July 31, 2025

PROJECT NO. MDBCH25002

**RE: LIMITED STRUCTURAL FLOOD HARDENING STUDY OF MADEIRA BEACH CITY HALL
MADEIRA BEACH CITY HALL RENOVATION & FLOOD HARDENING
300 MUNICIPAL DR.
MADEIRA BEACH, FL 33708**

Figure 2 – CMU to Column Connection

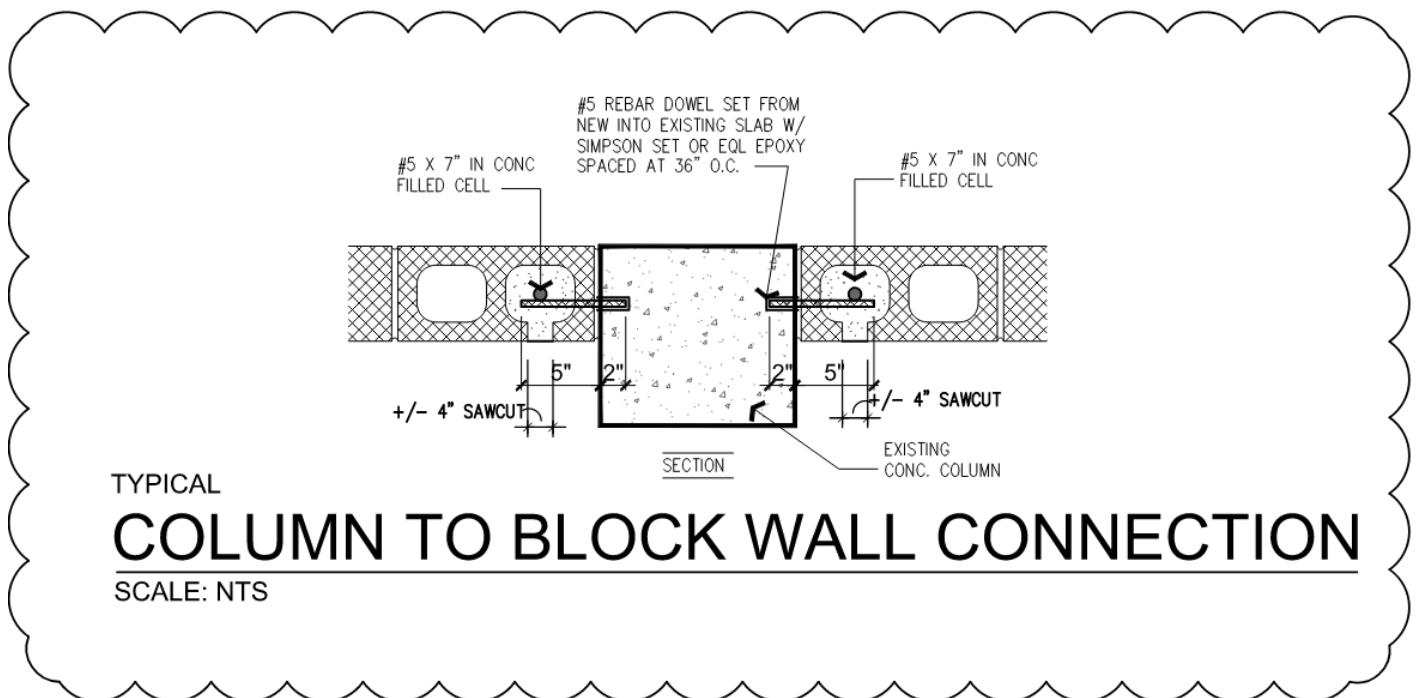
Infill wall to existing column connections are specified in the below detail on sheet A-2.0

PAI Comment – Based on Scanning of the structure the exterior columns appear to be tied into the exterior walls by horizontal rebar on 16-inch centers. The rebar is estimated to extend 6 to 8 inches into the wall columns.

Figure 4 – Sketch of Recommended Repair to Meet Original Code

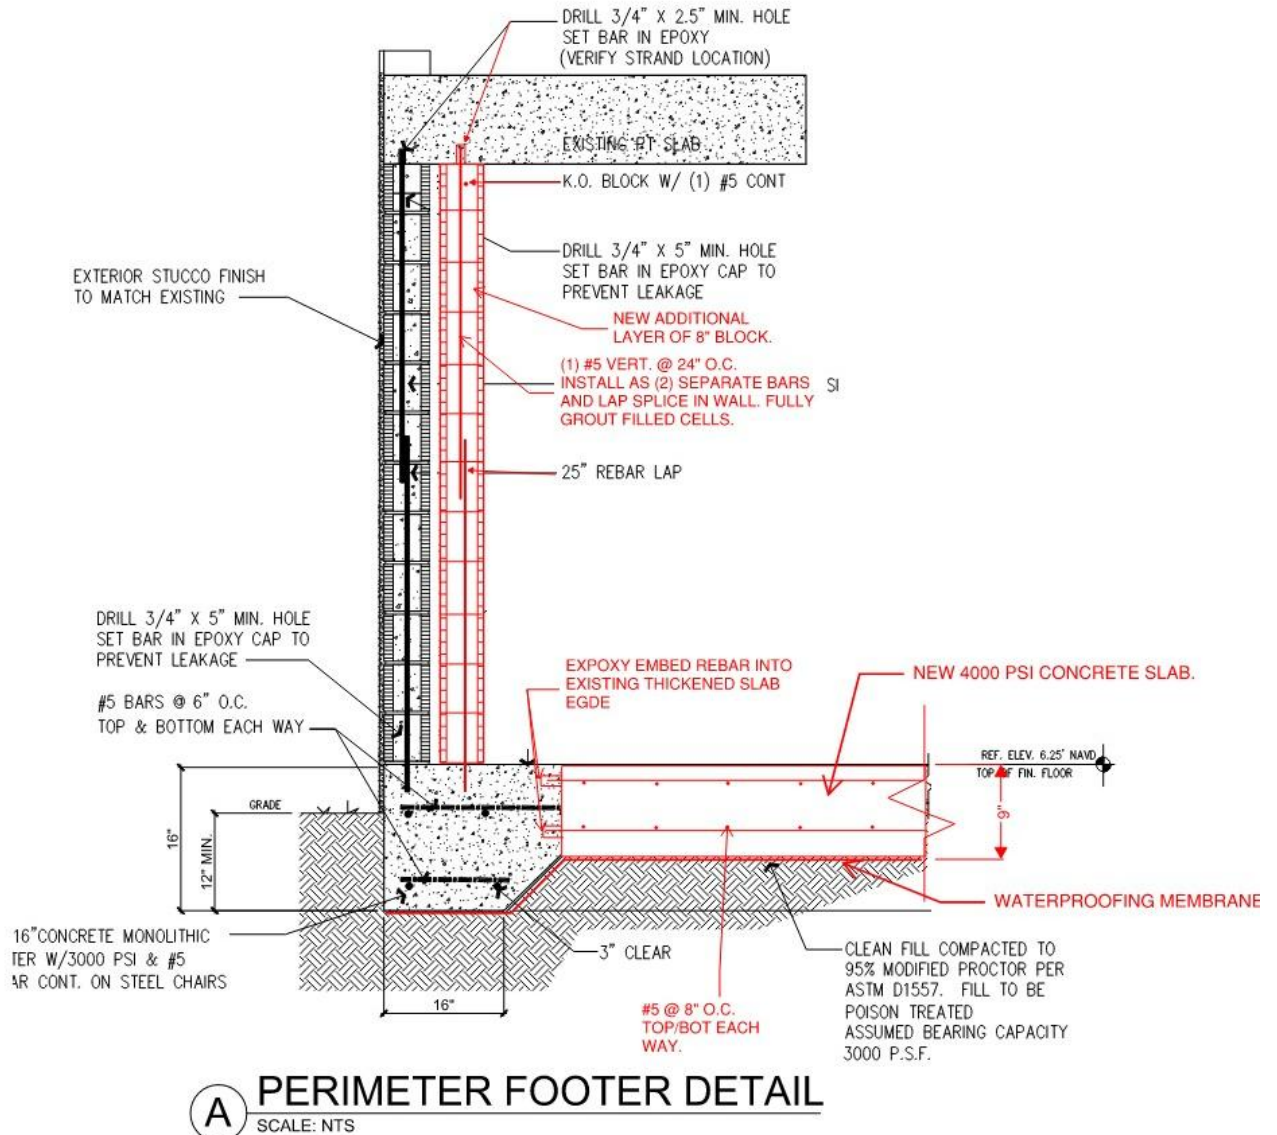
For the exterior walls to meet the existing code requirements for flood loading from the original design a new 2nd 8" CMU walls would need to be constructed and placed behind the face of the existing 8" CMU wall. The new wall would act as 16" CMU wall against the breaking wave force acting on the building. The new wall would satisfy requirements for bending and for deflection. The new wall would need to be reinforced with (1) #5 vertical bar at 24" on center. The rebar would be centered within a filled cell in the wall. For bending stress, the new wall is at 94% capacity. The wall deflection would be 0.06" which is within the required deflection limit of L/360.

The 4" non reinforced slab would need to be removed and replaced with a 9" thick, 2-way mat slab. This new slab would be made from 4000 psi concrete with #5 rebar at 8 inches on center in each direction, for both top and bottom portions of the slab. The slab would be required to be supported by 16" diameter helical piles to resist the uplift forces from buoyance when at flood stage. The piles would be located no more than 12'-0" apart in each direction. A site-specific geotechnical testing, including Standard Penetration Testing (SPT) borings, would be required to determine the type, depth and size of piles to be installed below the new structural slab.

The conceptual structural hardening details have been included in the below **Figure 4**. The new CMU walls would need to be pinned together with rebar so they can function uniformly under flood loading.
